March 24, 2014

NOTICE OF ADDENDUM
ADDENDUM NO. 1
CONTRACT NO. 7206

STATE STREET RECONSTRUCTION
ASSESSMENT DISTRICT 2014

1 CIRCULAR SEATING NODE PLAN ENLARGEMENT
S-21 1/2"=1'-0"

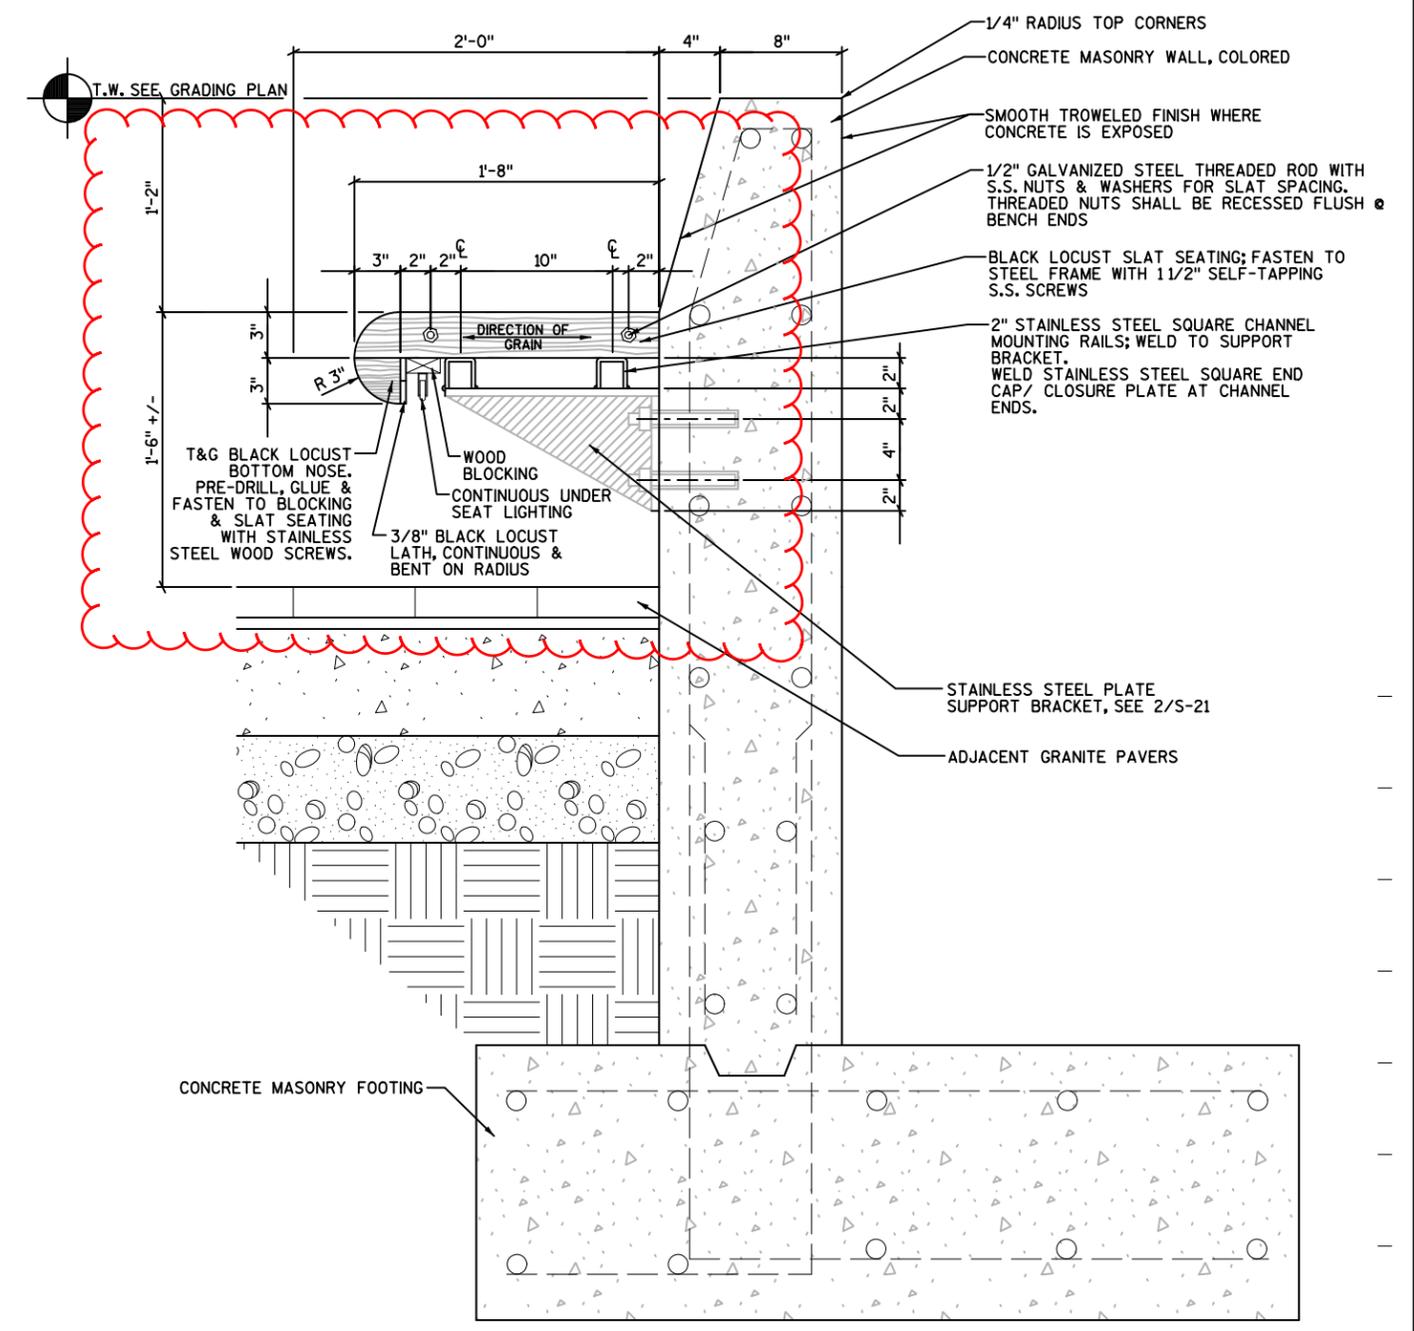
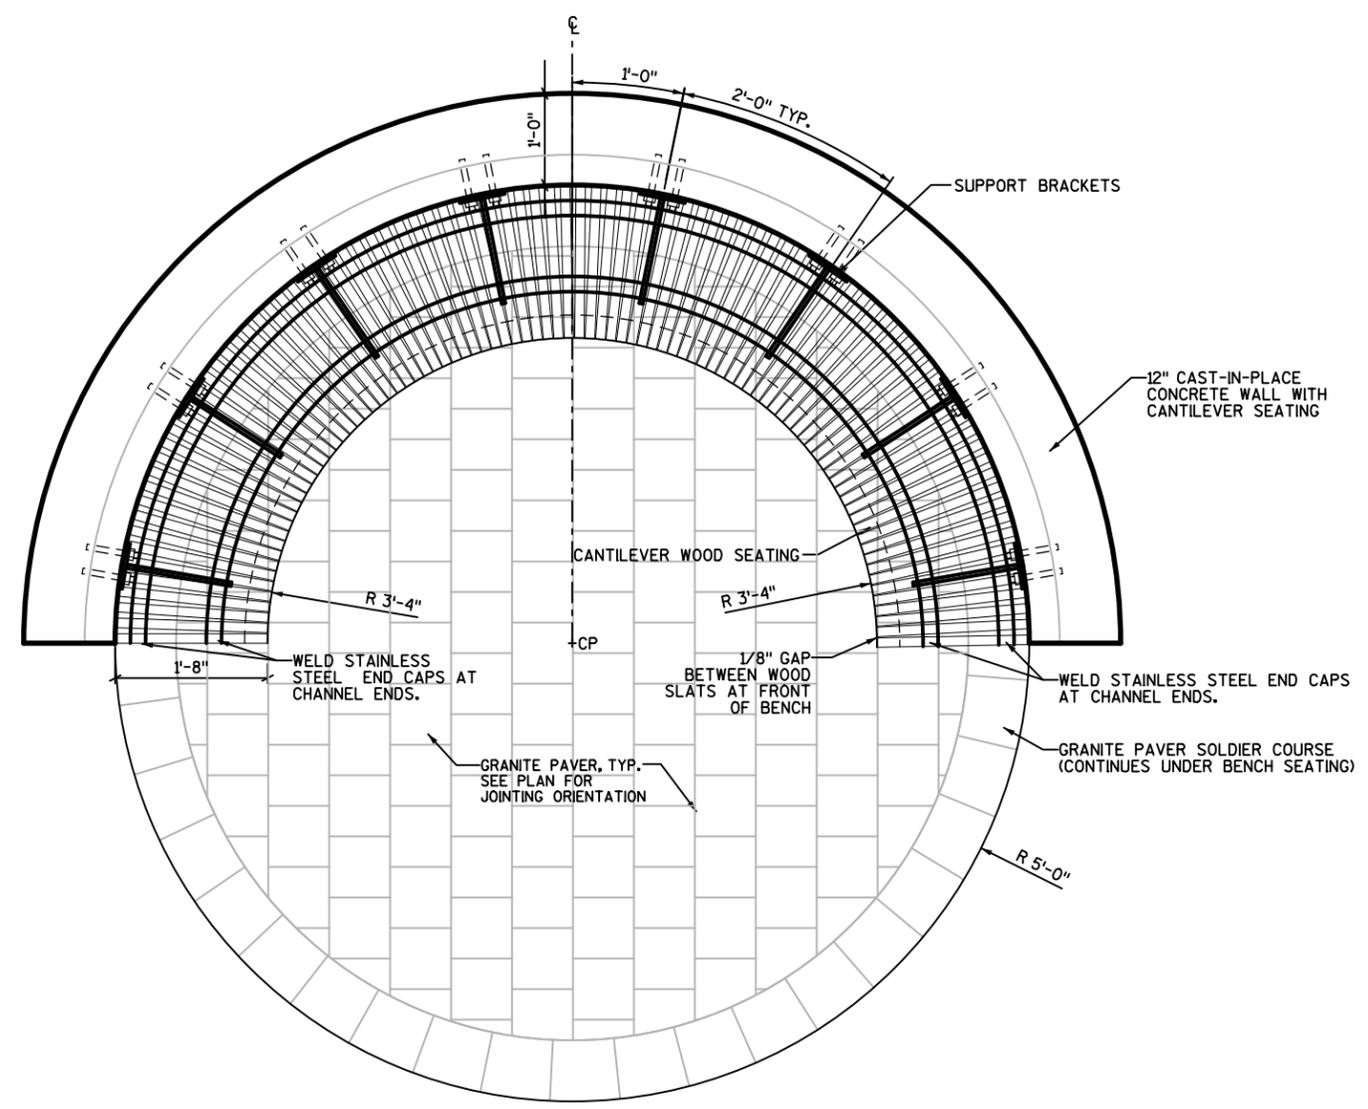
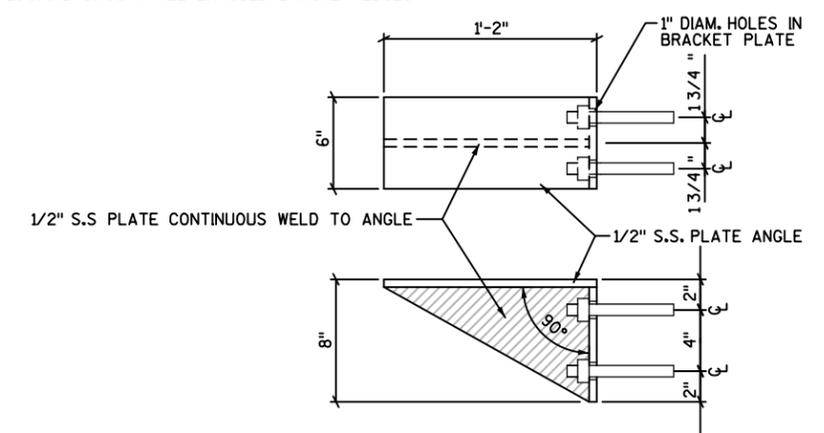
Replace Sheet S21 (Revised 3/20/14) – Modified detail for wood cantilever seating.

SHEET S21- CIRCULAR SEATING NODE PLAN ENLARGEMENT

Paver soldier course units can be flat on the inner and outer edge. The other two sides should be cut on an angle to form the radius. Each soldier course unit will be cut on two sides.

Revised 3/20/14 - Modified detail for bottom rail of wood seat.

Modify BID ITEM 90226 – CANTILEVER WOOD SEAT

Revise: Black locust wood slats and bottom nose supplied by 'Midwest Black Locust' (www.midwestblacklocust.com, (832-800-4625), or approved equal.

Wood slats: kiln dried, 6/4, S1E, with radius edge as shown on Drawings.

Delete: Bottom rail: kiln dried. Milled and shaped as shown on Drawings. 4'-0" min length members.

Add: Bottom nose: kiln dried. Milled and shaped to fit tongue & groove with wood slats above and as shown on Drawings.

Add: 3/8" x 1.5" Black Locust Lath. Air-dried; Clear & straight grain; Free of knots, checks, and other imperfections.

Add: Exterior-Grade Waterproof Wood Glue. ASTM D-4236. TiteBond III or approved equal.

1 WOOD DECKING @ LEAF BASE PLAN ENLARGEMENT
1/2"=1'-0"

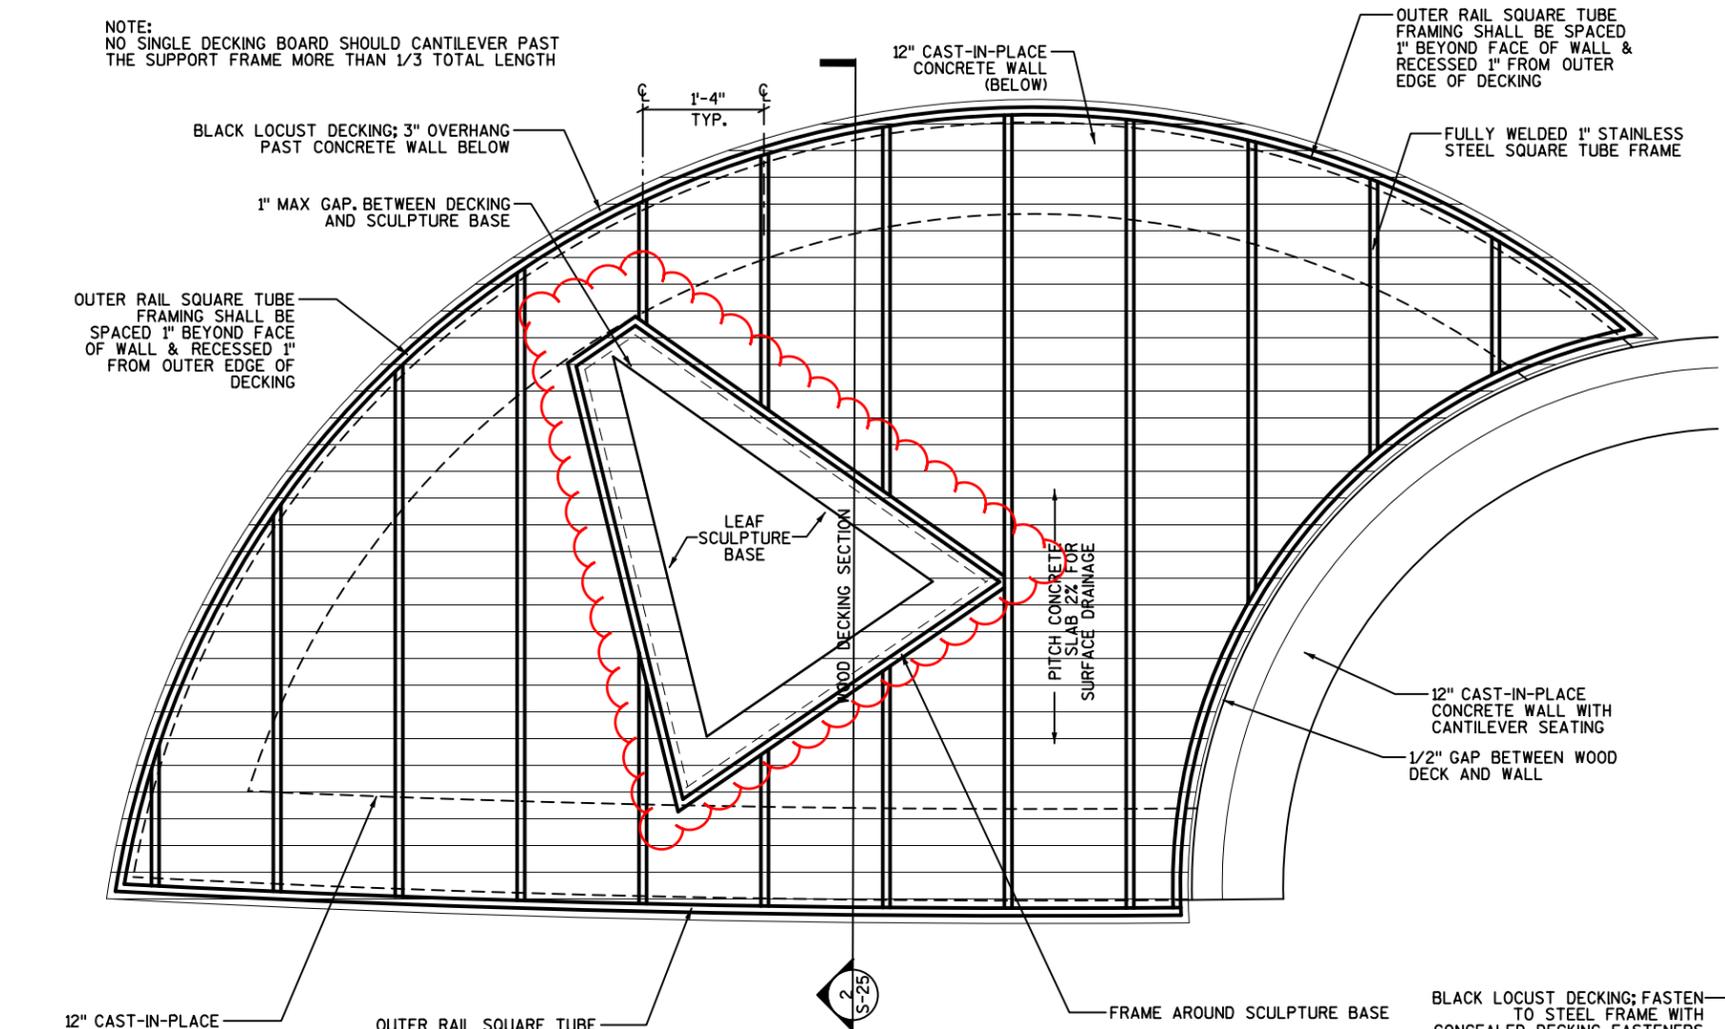
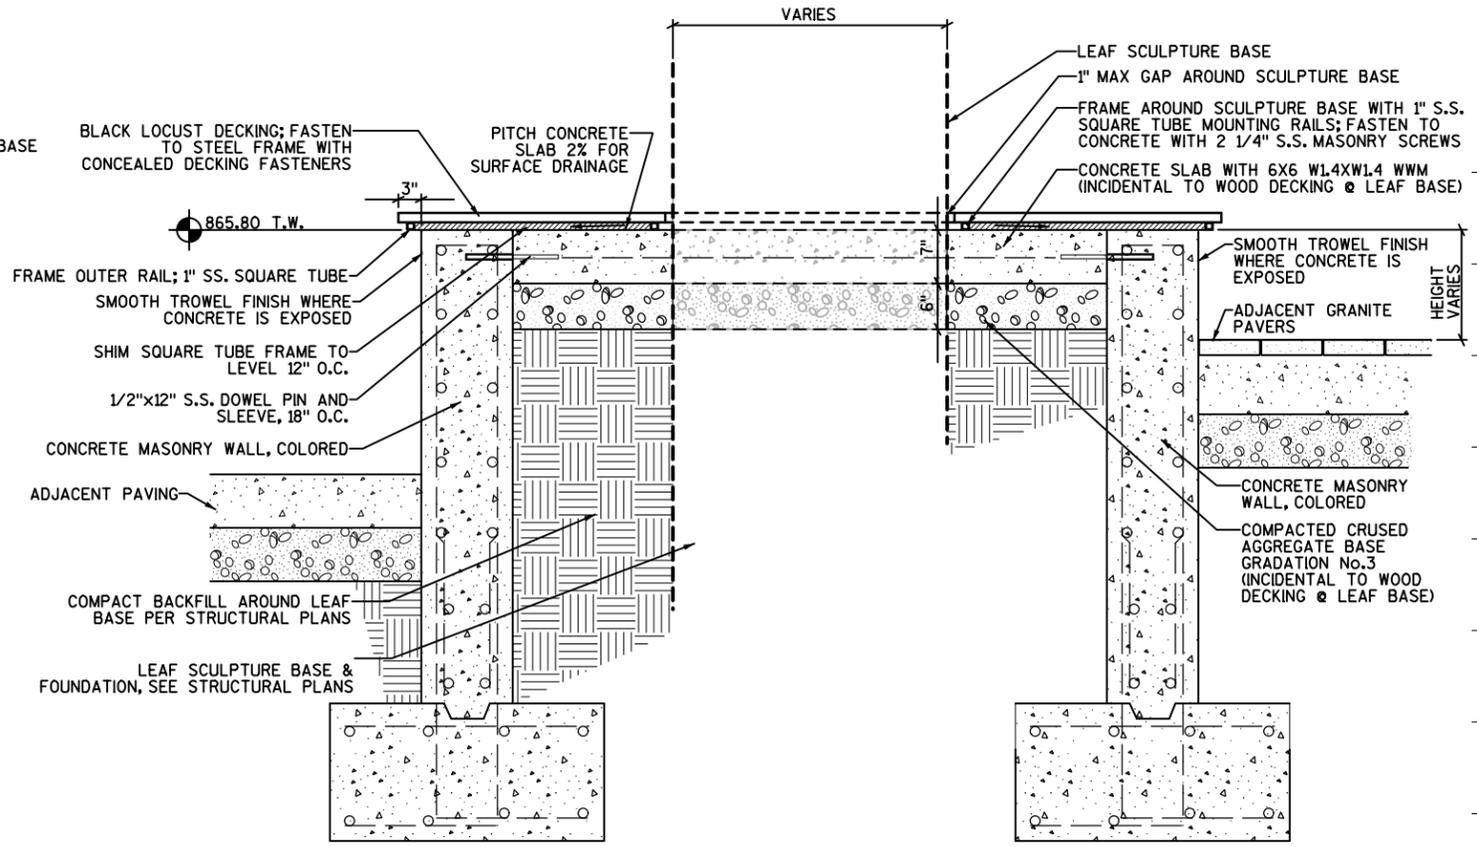
Replace Sheet S25 (Revised 3/18/14) – Updated Wood Decking @ LEAF Base detail – matched shape of

BID ITEM 90225 WOOD DECKING AT LEAF BASE

Minimum length for wood decking is 8 feet (unless cut per design detail). Minimum width is 3 ½ inch.

Revised 3/18/14 - Updated Leaf Sculpture Base Shape
